Access Compliance Report Public Rights-of-Way (Pedestrian Signals)

Main Street: BALL_RD Cross Street: PERDIDO_ST Location: SW

ADA ID: SGRK210923173904 Signal Type: One Push Button-Non APS Overall Compliance: No Severity Scores: BTN 1: 35 BTN 2: N/A No BTN: N/A

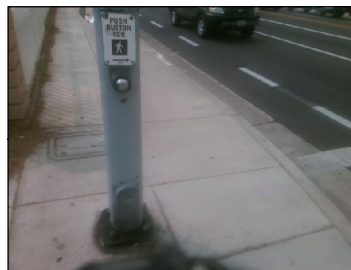
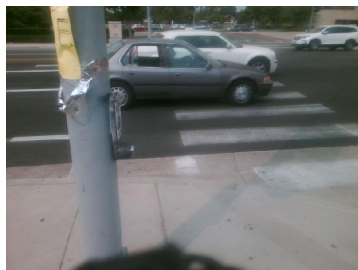
OC Std/PROW: R404.2, MUTCD 4e.08

Possible Solutions: Replace Signal Push Button With APS Button. Remove and Replace Clear Space.
